VILLAGE OF GERMANTOWN
N112 W17001 MEQUON ROAD
GERMANTOWN, WI 53022

MEETING: REGULAR MEETING OF THE VILLAGE BOARD

DATE AND TIME: MONDAY, March 18, 2019 7:00 p.m.

CONDITIONAL USE PERMIT (CUP) APPLICATION & SITE PLAN REVIEW

SHEET NO:
C1.3
JOB NO:
ENG-1465

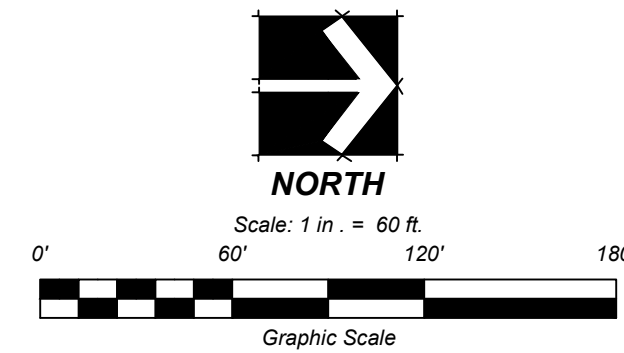
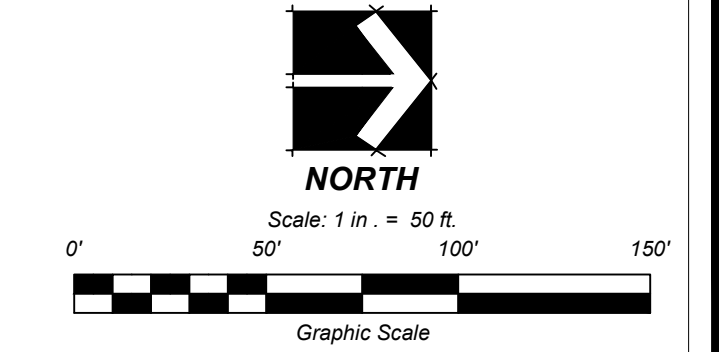
- q. Remove the "Additional Parking Area" on sheet C1.3 or account for the additional impervious area in the Storm Water Management Plan.
- r. On sheet C1.10 details of light-duty and heavy-duty asphalt are to be provided.

The parking calculations note on Sheet C1.3 indicates that an additional parking area with 44 stalls will be installed "... if required for future tenant". Please explain what future tenant may operate from the property and when that might occur. Will the additional parking area be constructed to the same standard as the other vehicle parking area? e.g. curb & gutter, landscaped islands, etc. Has the additional impervious surface for this additional parking area been accounted for in the storm water analysis? If so, please indicate as much on the plan sheet(s) and/or notes so that it's clear this future parking area is proposed to be included in the initial site plan approval (and not require separate approval if nothing changes in the design/layout between the original proposal and whenever the additional parking area is needed).

q. Remove the "Additional Parking Area" on sheet C1.3 or account for the additional impervious area in the Storm Water Management Plan.

C1.8

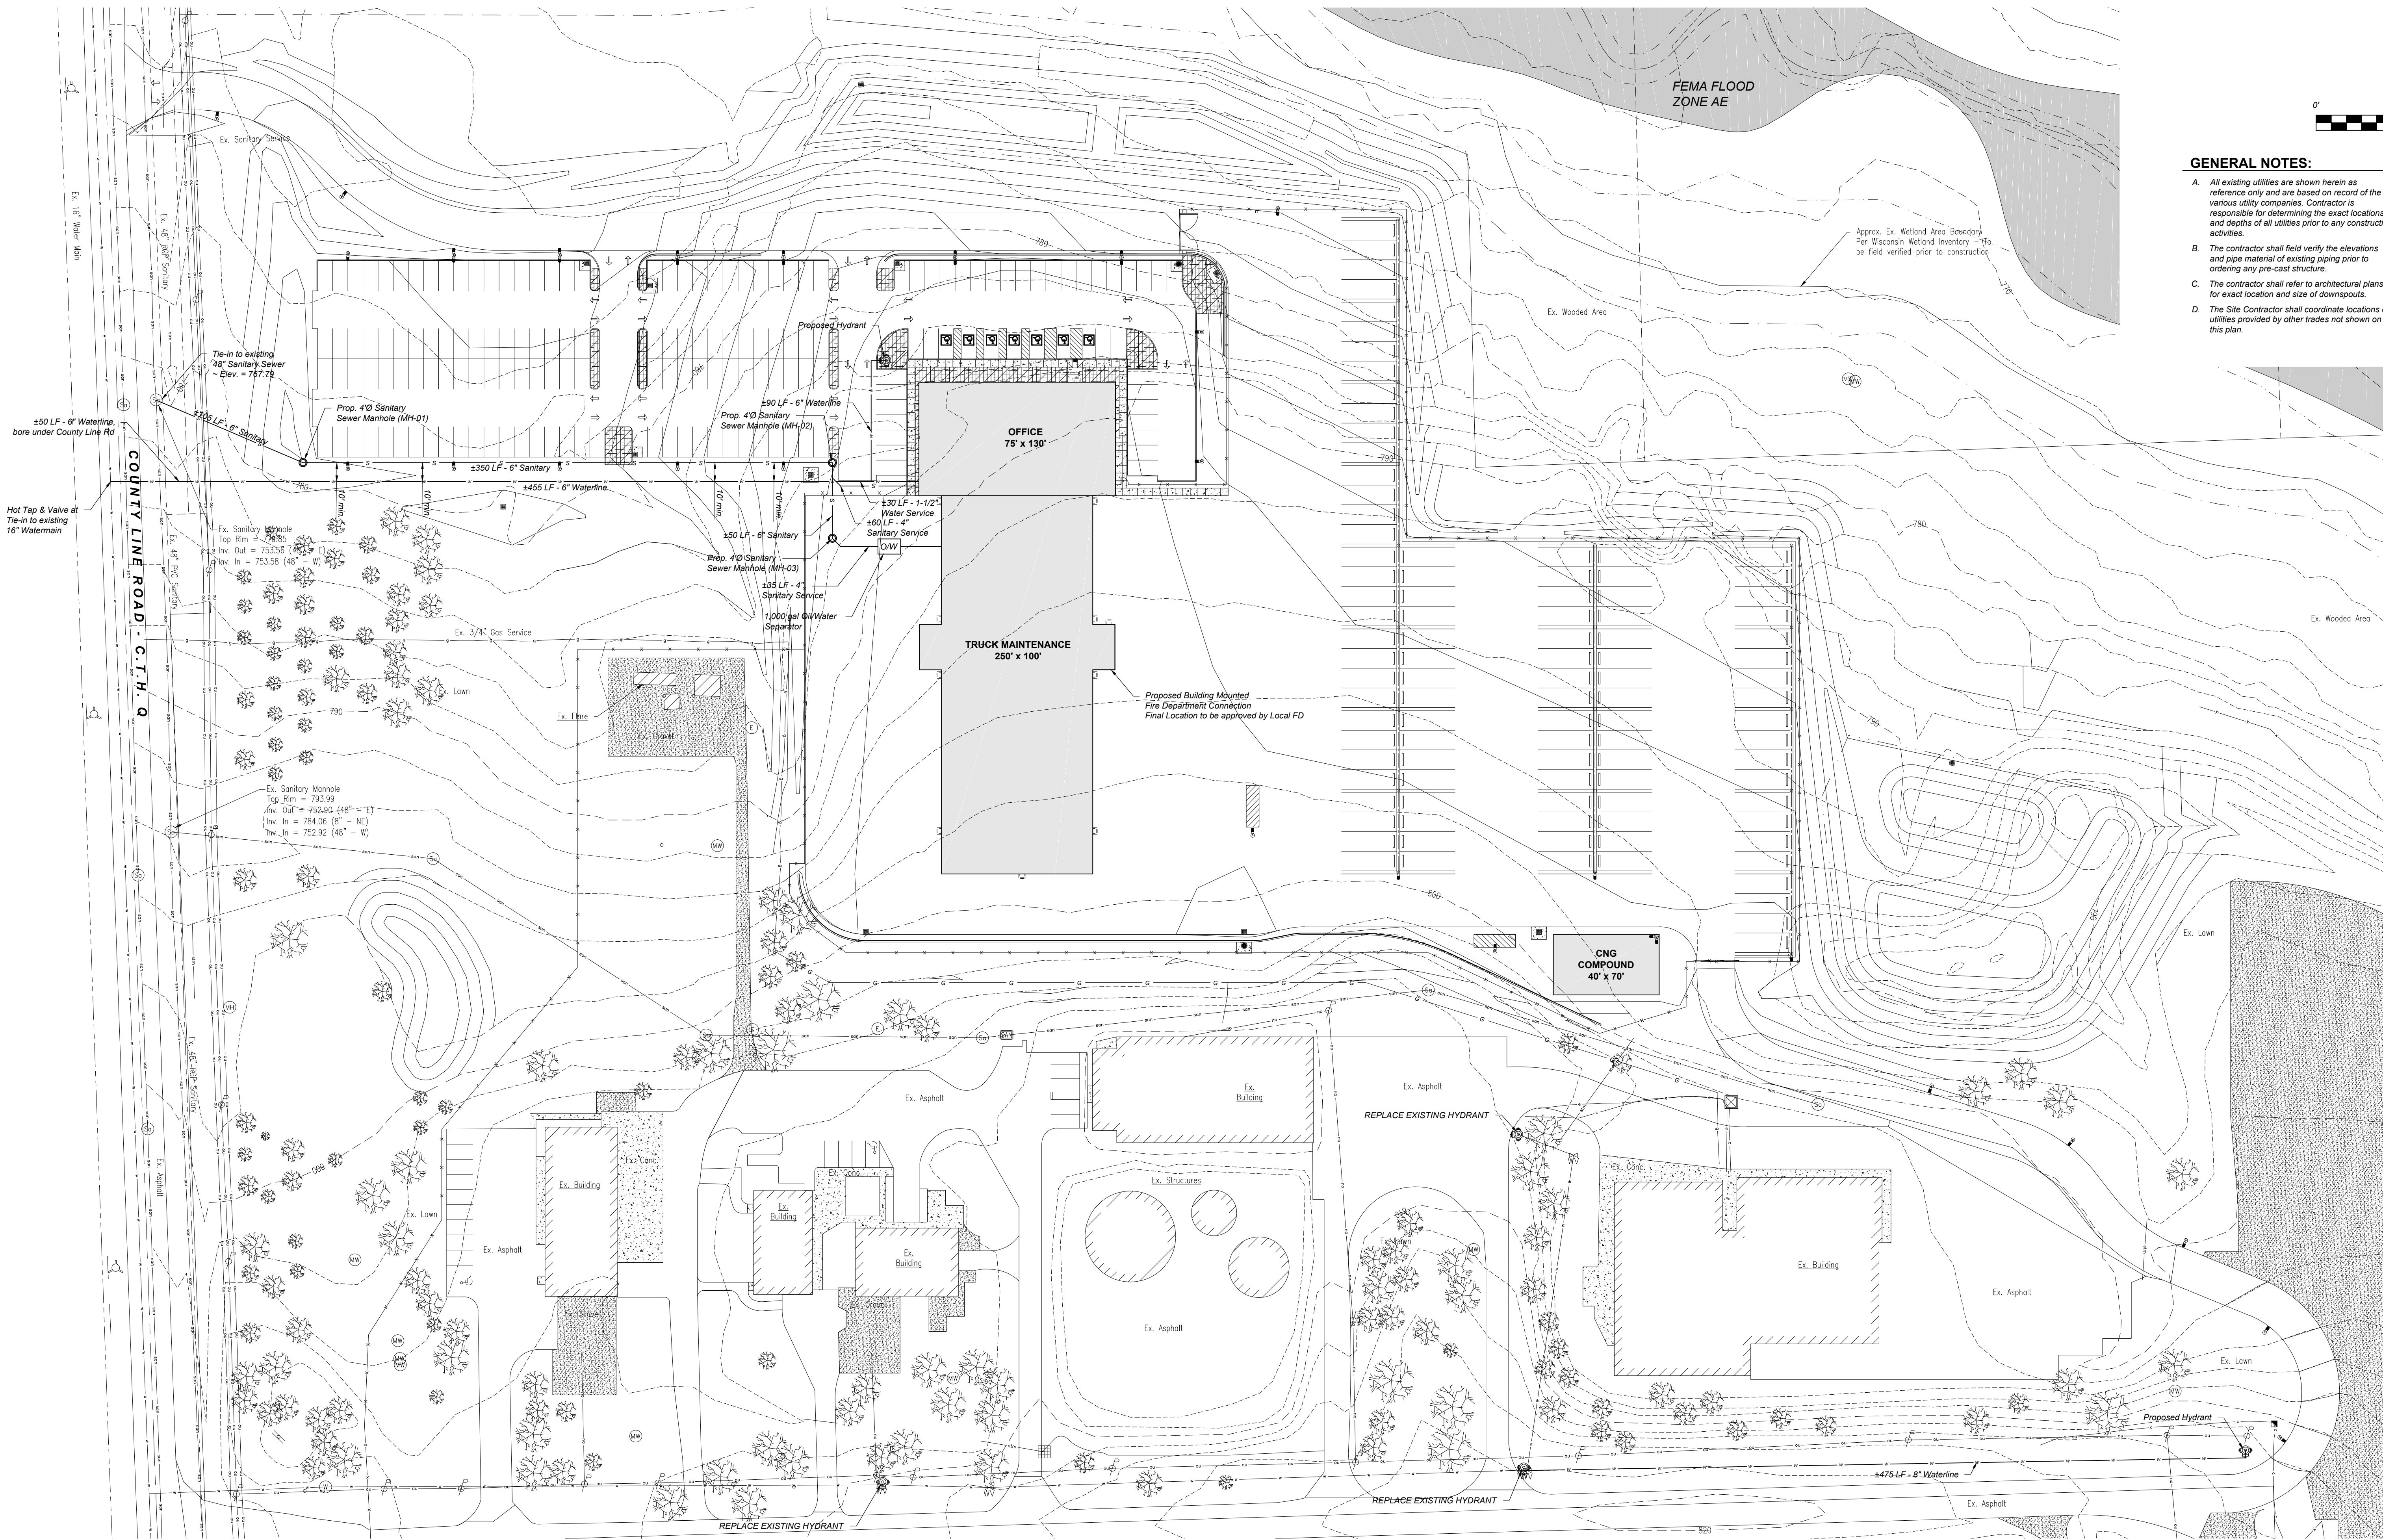
As shown on the Storm Water Management Plan (Sheet C1.8), the facility will be served by two (2) storm water retention basins. One basin is located west of the building and primary driveway into the site and the second basin located in the northeast portion of the site. On-site storm sewers, catch basins, roof drains, ditching and swales will be used to divert run-off into the two basins.

Response: Rip-Rap protection has been extended on the site plan. Level spreaders have been added near the boundary of the site outlet points. See plan set sheet C1.8.

Response: Shear stress calculations were completed for each of the 4 major channels. Based on the shear stress results, a Class II, Type B matting will be adequate for each channel. A list of allowable ECRM has been added to the SWR and callouts for the ditch lines have been added to the site plan sheet C1.8.

<i>WASTE MANAGEMENT</i>
PROJECT: TRUCK MAINTENANCE FACILITY GERMANTOWN, WI
SHEET TITLE: SITE LANDSCAPING PLAN

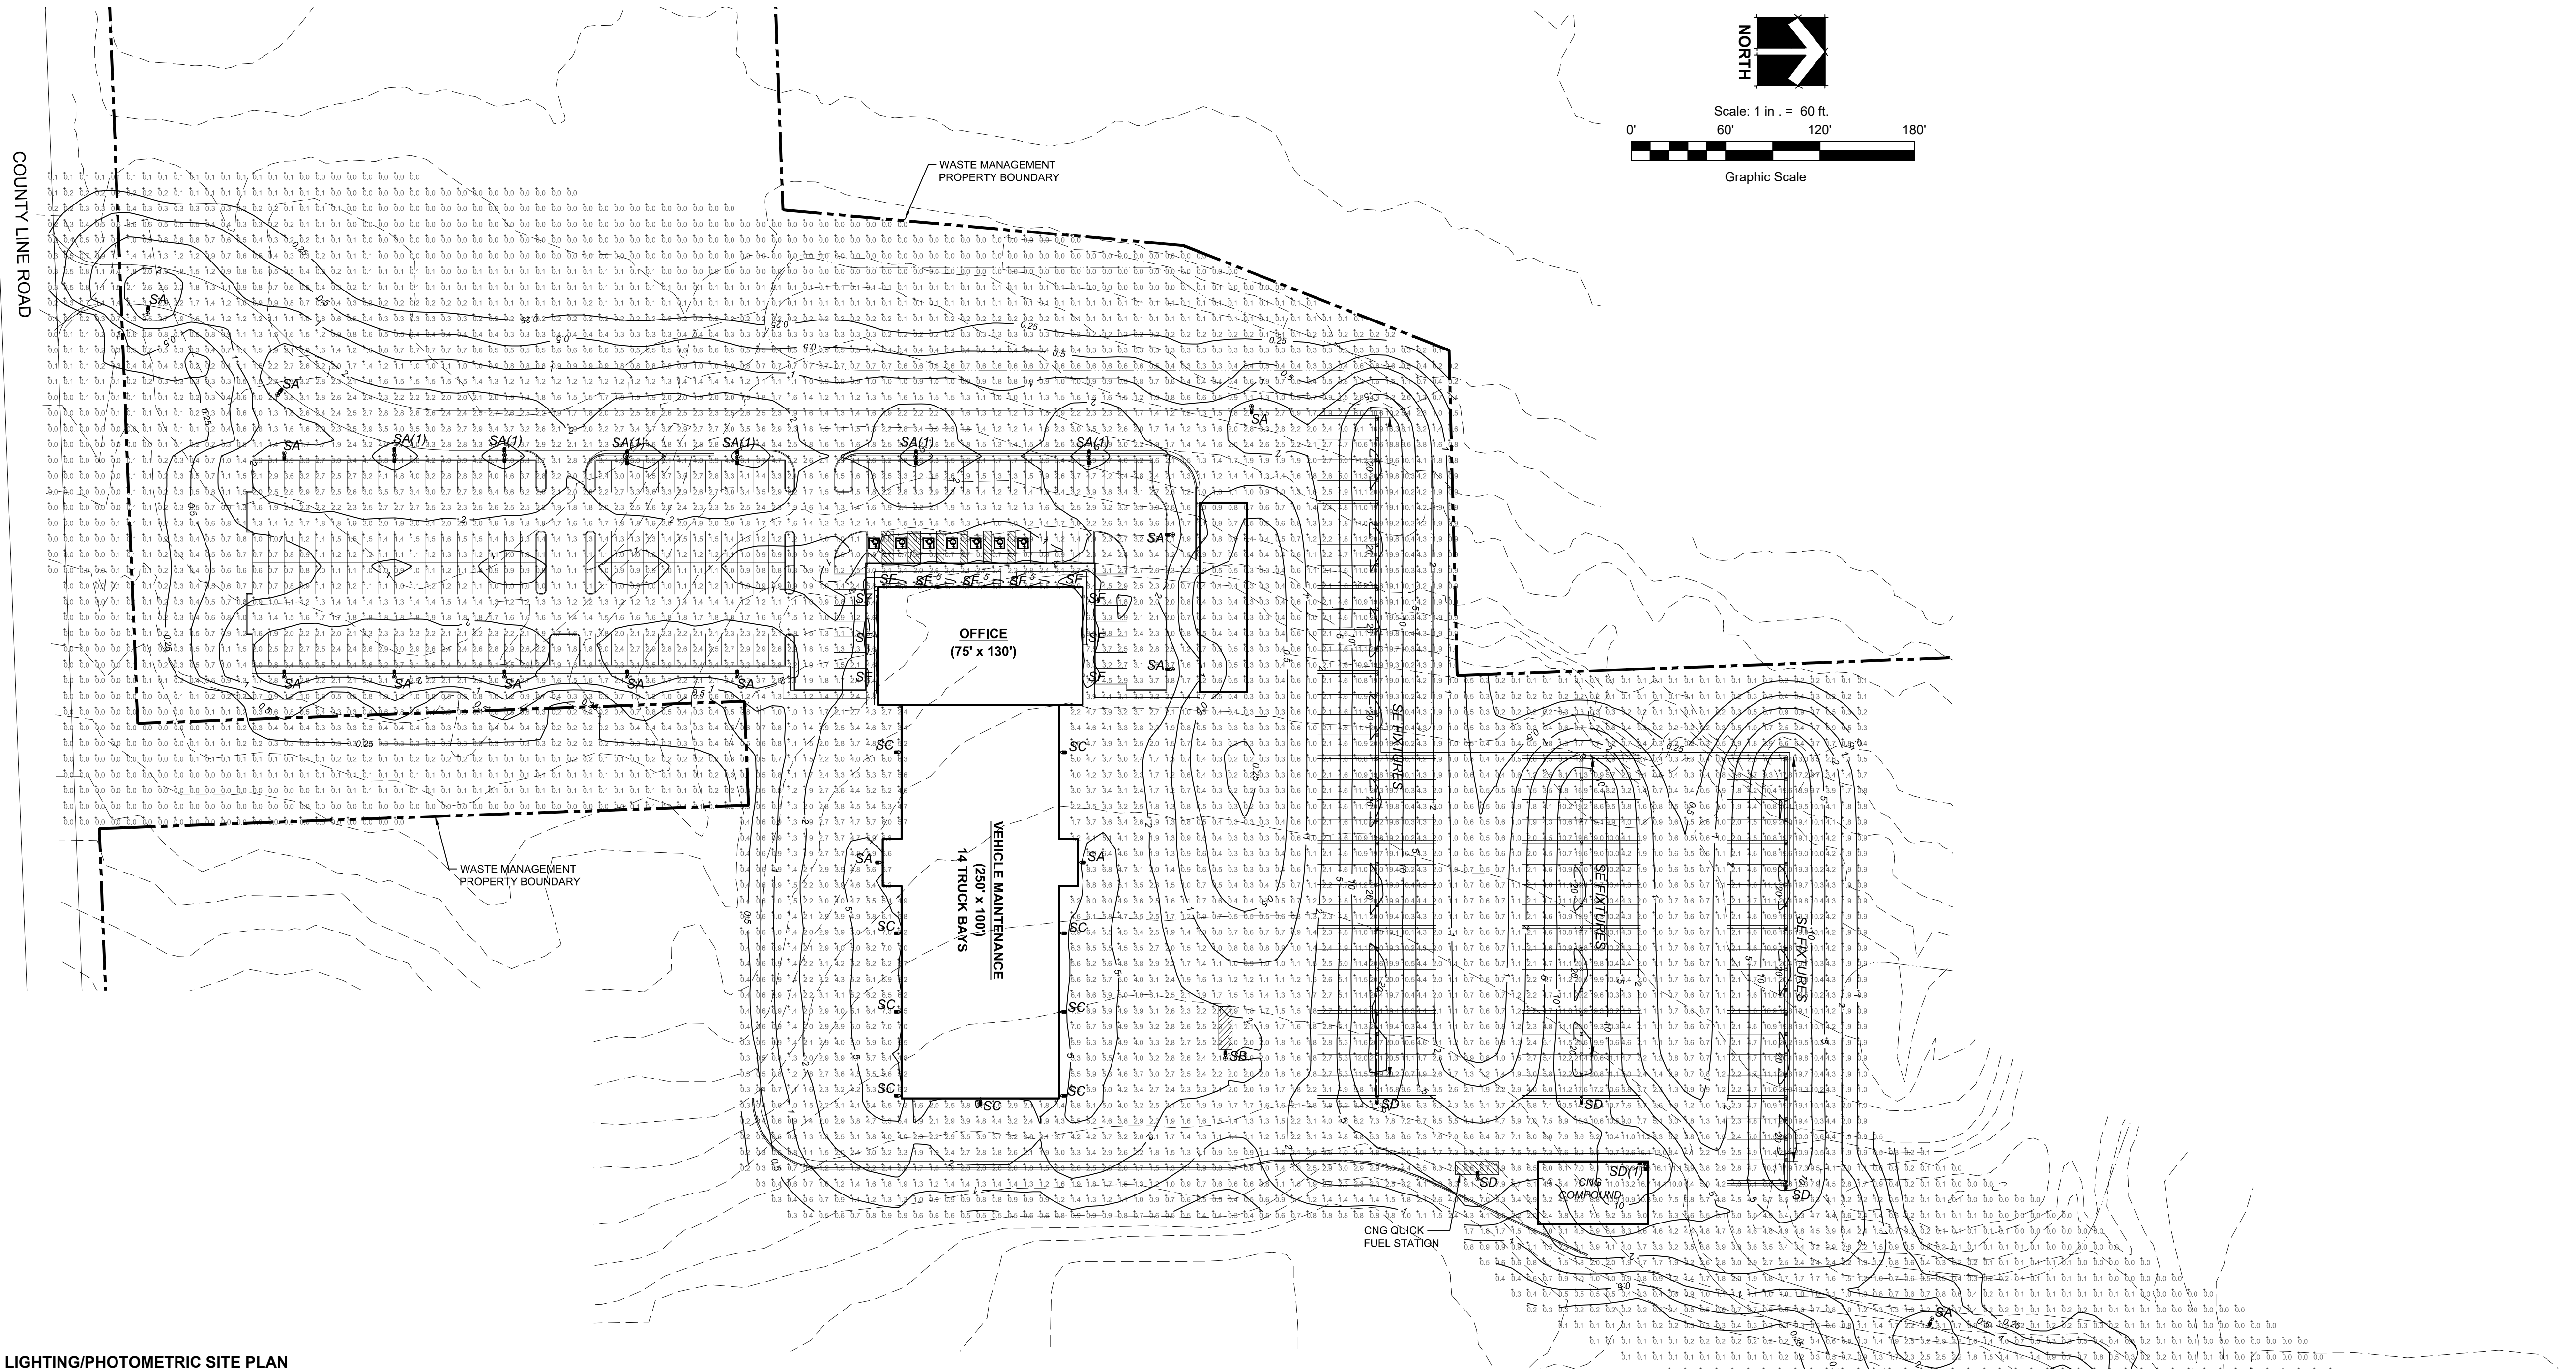
The landscape plan is adequate except for the street tree requirement along County Line Road. While most of the trees proposed on the site are evergreen trees, additional deciduous trees are required to satisfy the street tree requirement. The landscape plan needs to be revised to address this deficiency. At a minimum, additional street trees in an amount equal to one (1) tree per 50 feet of road frontage shall be added to the plan and installed in addition to the site landscaping already shown in the landscape plan. Further, the landscape plan specifies 3" caliper White Spruce and Black Hills Spruce trees. Unlike deciduous trees, evergreen trees are typically discussed in terms of total height (vs. trunk caliper) under the Village's landscaping and street tree guidelines. A typical planted size of evergreen trees in Germantown is a minimum of 6-8 feet. If the 3" caliper evergreen trees that WM intends to install as shown on the landscape plan are, in fact, a minimum of 6'-8', nothing more needs to be done. However, if a 3" caliper evergreen tree is less than 6' in height, the landscape plan needs to be revised to reflect a minimum planted height of 6'-8' for evergreen trees.

The proposed landscaping along the south and east sides of the new parking area closest to County Line Road is sparse. Because the plant materials are shown in the landscaping plan Sheet L1.0 at full growth (e.g. 2" dia deciduous trees shown with 35' crown dia, 5-gal Spirea @ 5' spacing shown with 5' dia spread) the plan appears more "robust" than reality.
